# **AERONAUTICAL ACCESSORIES, INC.**

## **ALERT SERVICE BULLETIN**

**ASB No. AA-09107**

**SUBJECT:** **Cockpit Voice / Flight Data Recorder  
412-634-001 / 412-634-003**

Figure 1. Original Configuration

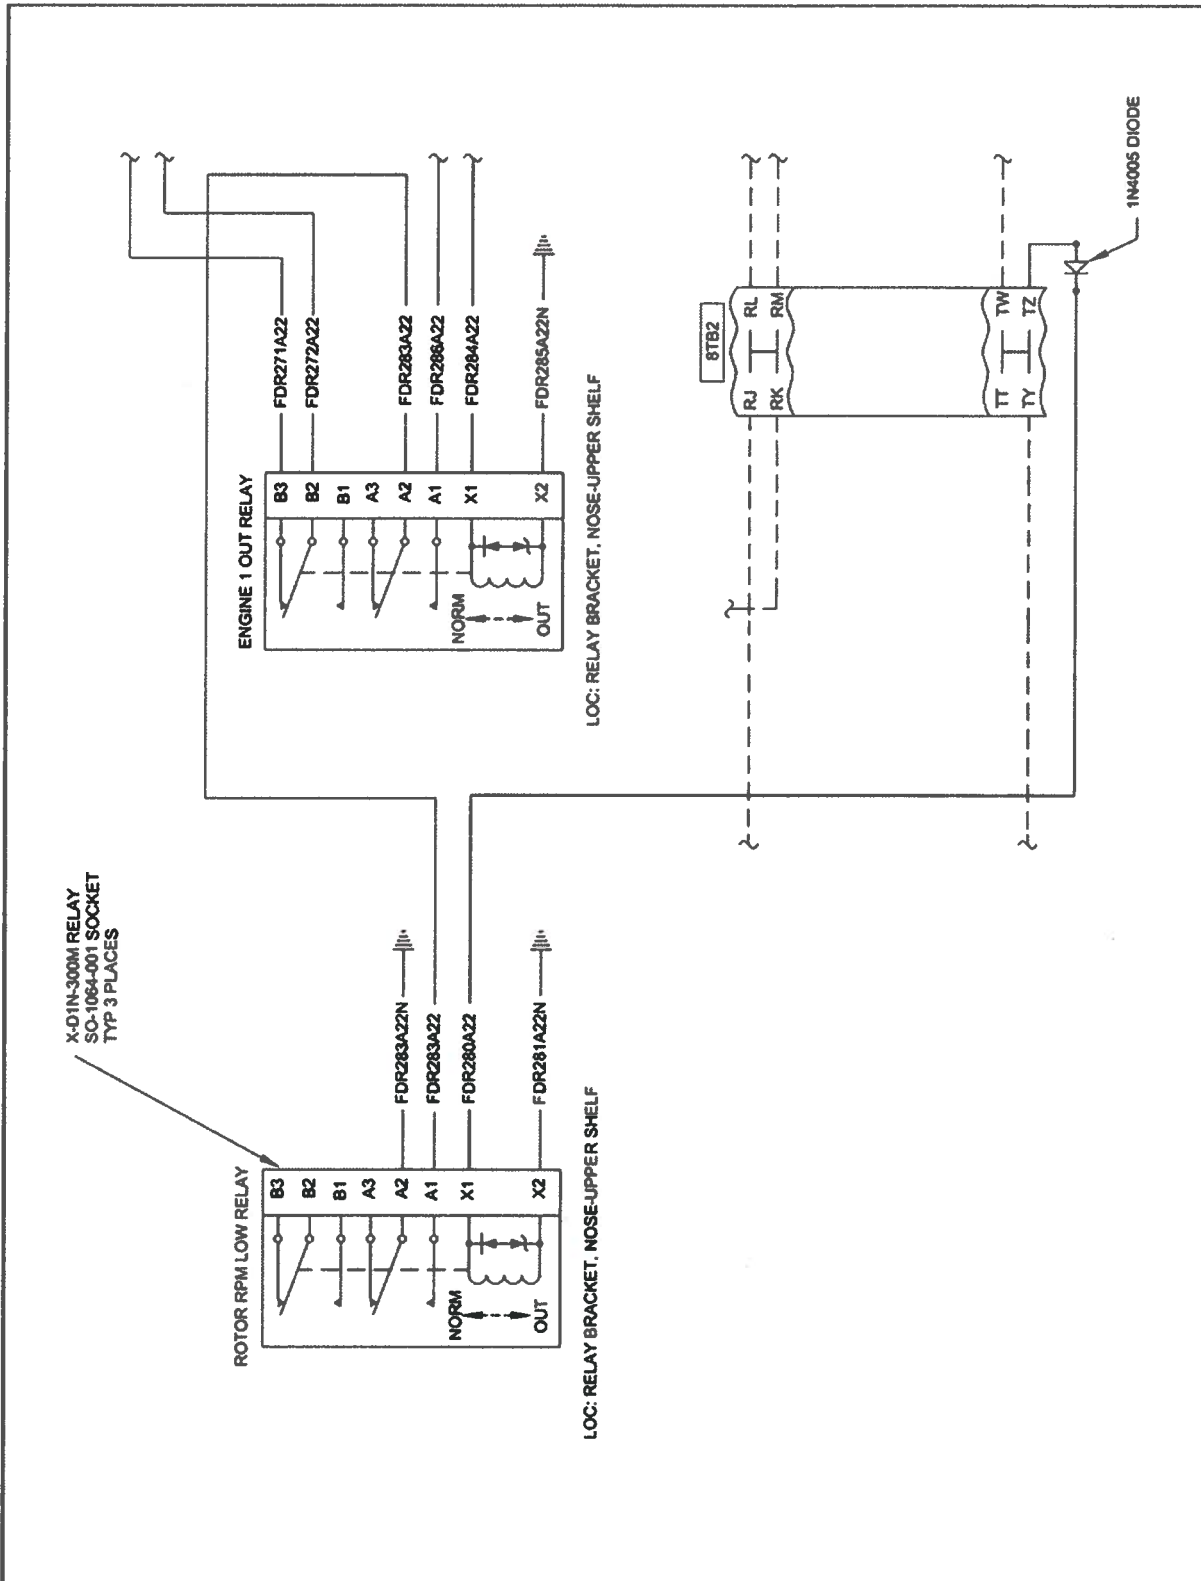
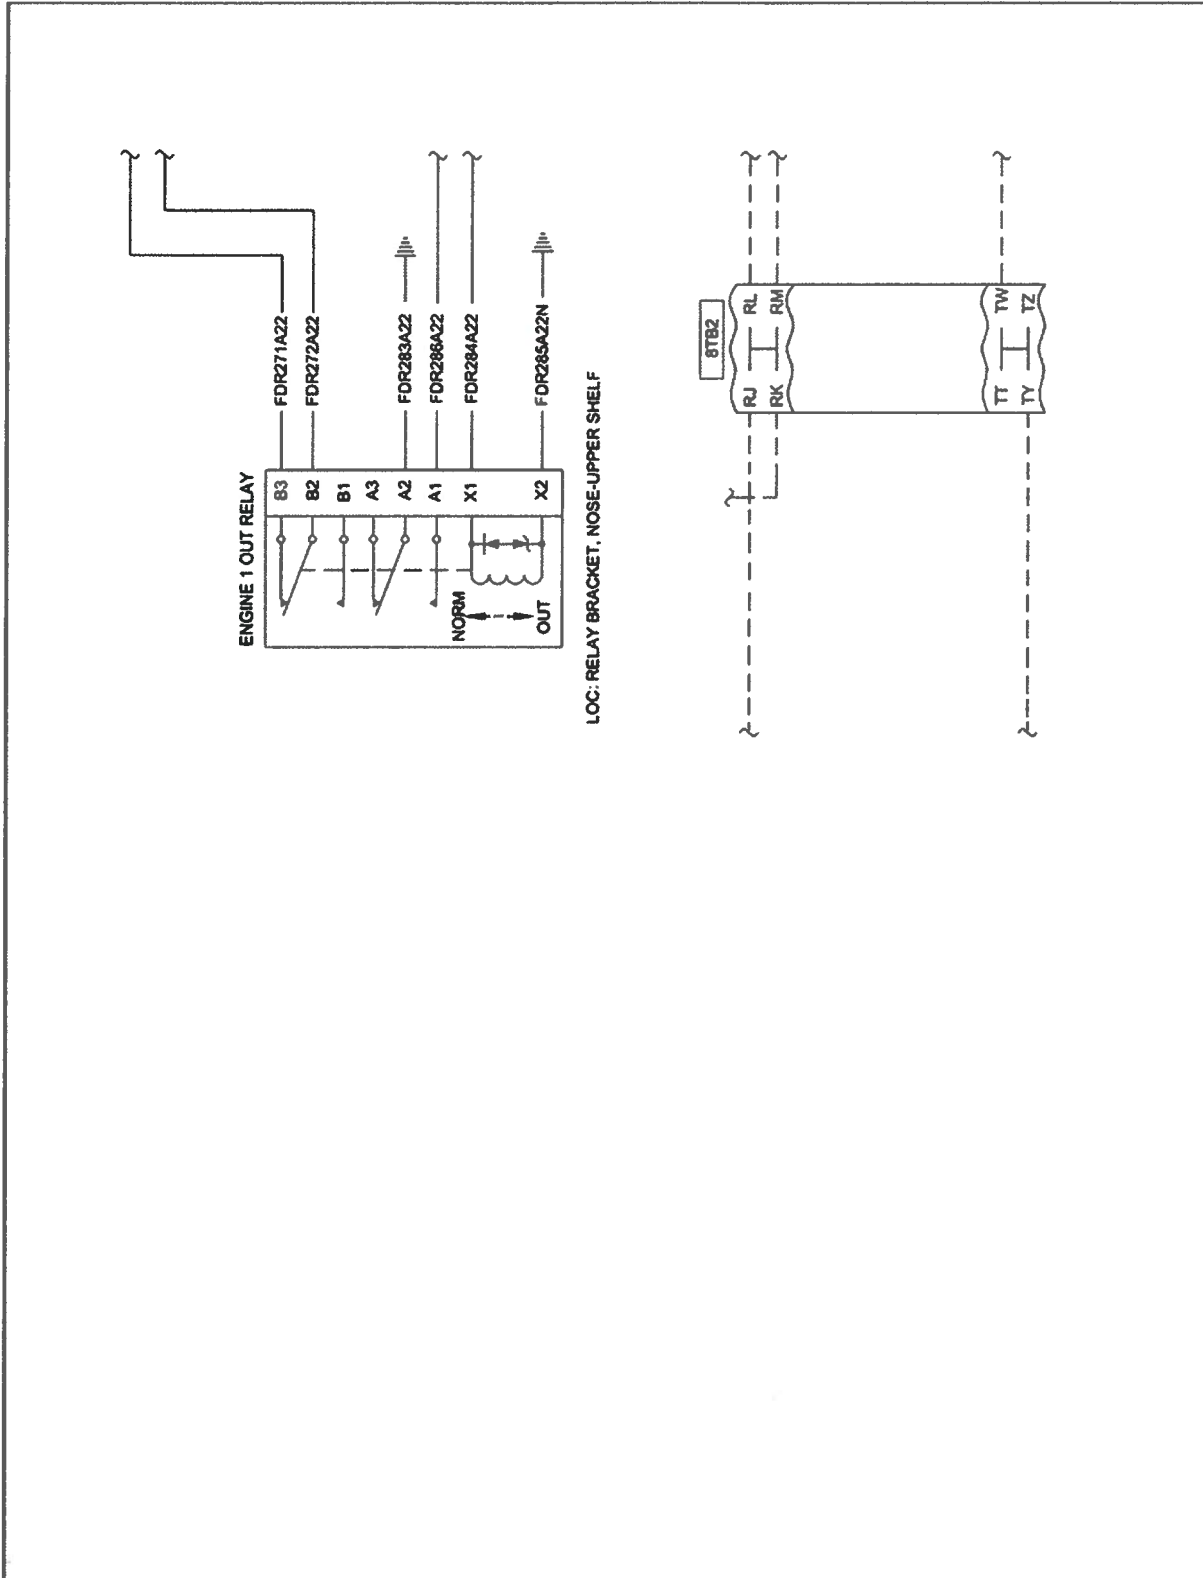
The CV/FDR is currently wired in accordance with Aeronautical Accessories, Inc. Installation Instructions, report AA-05153, revision J (and prior revisions) and drawing, Electrical Installation – CV/FDR, 412-628, revision H (and prior revisions) (Figure 1). Accomplishment of this bulletin will upgrade CV/FDR installation in accordance with Aeronautical Accessories, Inc. Installation Instructions, report AA-05153, revision K (and later revisions) and drawing, Electrical Installation – CV/FDR, 412-628, revision I (and later revisions) (Figure 2).

1. Prepare the helicopter for maintenance. Disconnect the aircraft battery.
2. Gain access to the mounting location of the ROTOR RPM LOW RELAY (typical, aircraft upper nose shelf).
3. De-pin wires FDR283A22N (A2), FDR283A22 (A1), FDR280A22 (X1), and FDR281A22N (X2) from ROTOR RPM LOW RELAY. Remove Rotor RPM Low Relay.
4. Remove ground wires FDR283A22N and FDR281A22N.
5. From ENGINE 1 OUT RELAY (A2), run wire FDR283A22 to ground.
6. De-pin wire FDR280A22, with diode 1N4005 attached, from terminal block 8TB2 (TZ). Remove wire FDR280A22.
7. Modification complete. Perform post installation test procedure, CVR Stop Record Check, in accordance with Section 5 of Installation Instructions, report AA-05153, revision K or later approved revision. Return aircraft to service.
8. Annotate the helicopter historical records with accomplishment of this Bulletin.
